Access Compliance Report

Public Rights-of-Way

(Curb Ramps)

Intersection ID: 6347	Main Street: DALPHON_JONES_DR	Cross Street: KATHERINE_KIKER_RD	Location:	N
ADA ID: 91BEE0610726	Ramp Type: Perp	Initial Pass/Fail: Pass	Overall Compliance: No	Severity Score: 30

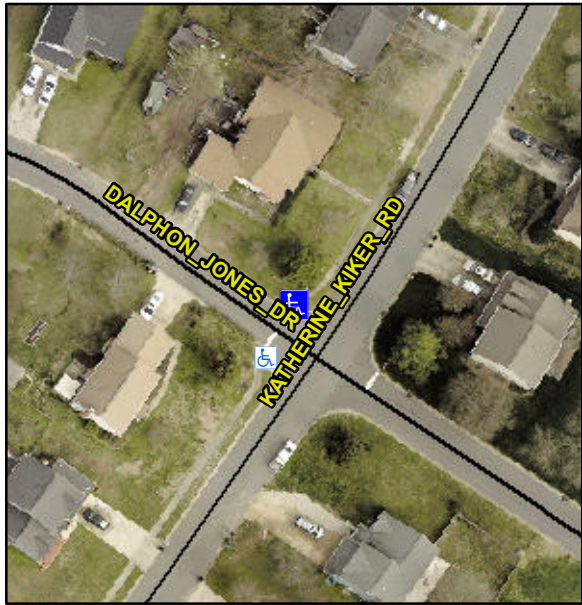
Codes/Mitigation Info/Possible Solution			Field Measurements/Component Compliance					
	Possible Solutions:		Compliance	Description	Data	Compliance	Description	Data
	Remove & Replace Entire Ramp.		N/A	Ramp Length (in)	49.5	Yes	Ramp Slope (%)	5.9
	Remove & Replace Gutter.		Yes	Ramp Width (in)	69.0	Yes	Ramp XSlope (%)	0.2
			N/A	Flare Type LT	Sloped	N/A	Flare Type RT	N/A
			N/A	Flare Slope LT (%)	4.1	N/A	Flare Slope RT (%)	4.3
			N/A	Flare Traversable LT?	No	N/A	Flare Traversable RT?	No
			No	Landing Length (in)	43.0	No	DWS Provided?	No
			Yes	Landing Width (in)	69.0	N/A	DWS Contrast?	No
			Yes	Landing Slope (%)	0.5	N/A	DWS Length (in)	N/A
			Yes	Landing X Slope (%)	1.2	N/A	DWS Full Width?	No
Surveyor Notes:		N/A	N/A	Landing Curb? (Y/N)	No	N/A	DWS Offset (in)	N/A
PROW/ADA:		Not Found, R304.2.1, R305, R302.7, R302.7.2, R304.5.4	N/A	Shared Landing?	No	No	Gutter Slope (%)	6.4
			No	Gutter Ponding?	Yes	Yes	Gutter X Slope (%)	1.3

No	Gutter Lip Ht (in)	1.0	N/A	Painted X Walk2?	N/A
			N/A	Painted X Walk1?	No		X Walk 2 Direction	N/A
				X Walk 1 Direction	To W		X Walk 2 Width (in)	N/A
			N/A	X Walk 1 Width (in)	N/A	N/A	X Walk 2 Slope (%)	N/A
				X Walk 1 Slope (%)	1.5		X Walk 2 X Slope (%)	N/A
				X Walk 1 X Slope (%)	0.4		Ramp inside XWalk2?	N/A
			N/A	Ramp inside XWalk1?	N/A	N/A	Clear Space?	Yes
				Road Slope (%)	N/A	N/A	Clear Space to XWalk (in)	N/A
				Road X Slope (%)	N/A	N/A	Storm Grate/Utility Hazard?	No
			Yes	Any Obstructions?	No	Yes	Storm Grate/Utility Type	
				Obstruction Type				
						N/A		N/A
						Yes	Surface Condition? (G/P)	Good
Total Cost:		\$ 2600.00
